ATTACHMENT FOUR
 PROPOSED TECHNICAL SPECIFICATION REVISIONS
 FOR
 RELAXED AXIAL OFFSET CONTROL (RAOC)

ATTACHMENT FIVE
PRELIMINARY CYCLE 6 COLR CHANGES FOR
RELAXED AXIAL OFFSET CONTROL (RAOC)

FIGURE B 3/4.2-1
TYPICAL INDICATED AXIAL FLUX DIFFERENCE VERSUS THERMAL POWER

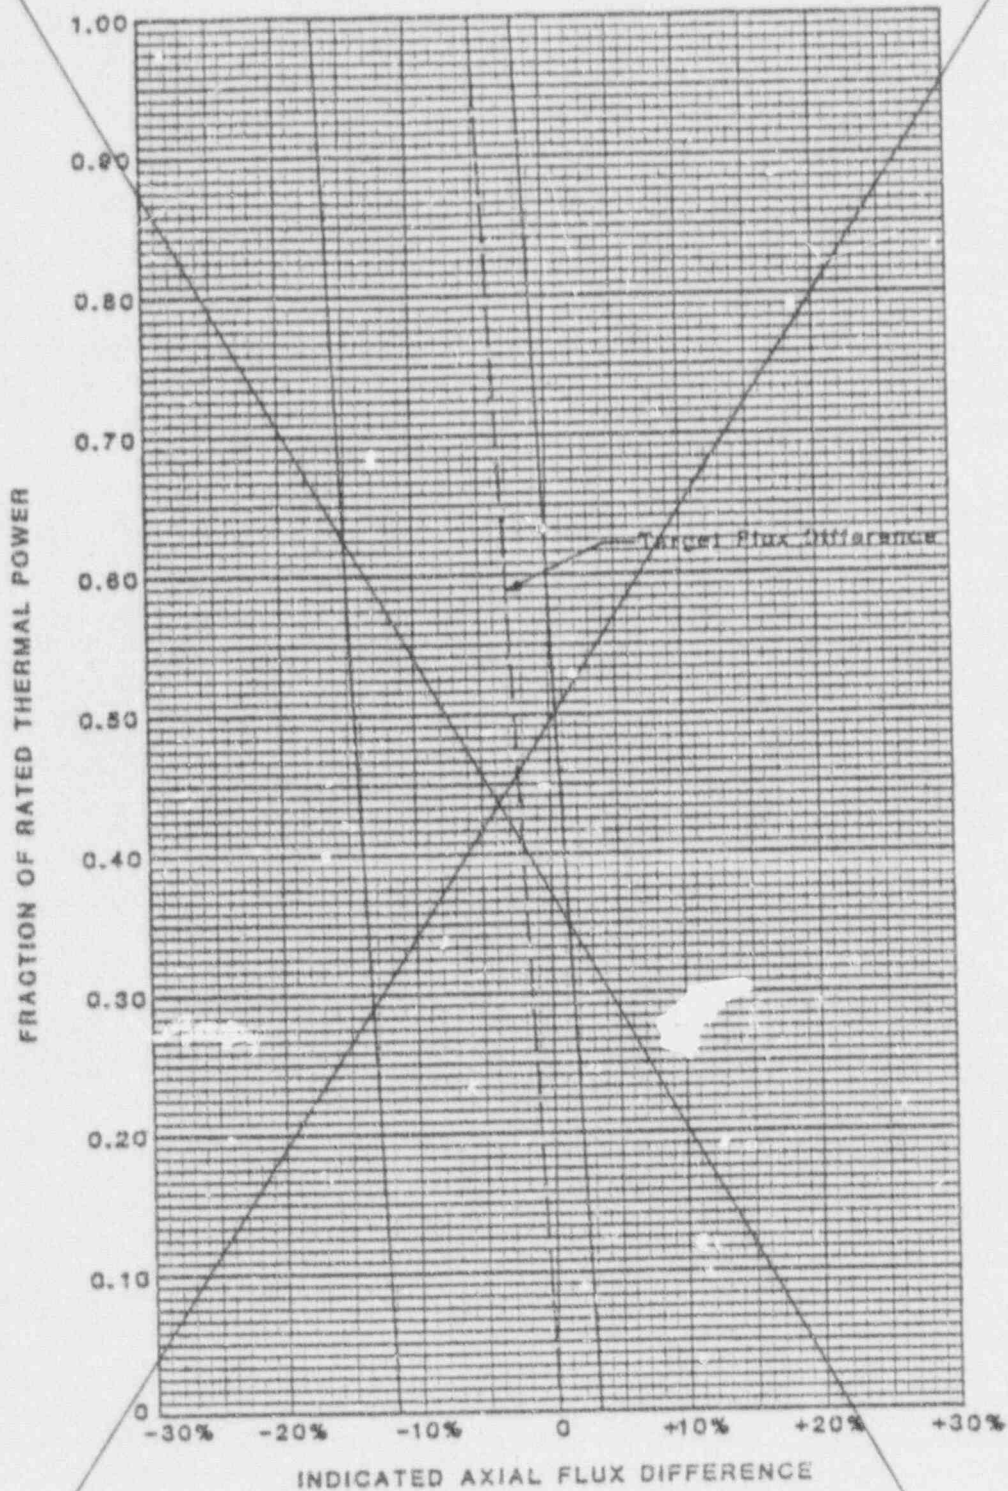
Figure B 3/4.2-1 shows a typical monthly target band.

DELETED
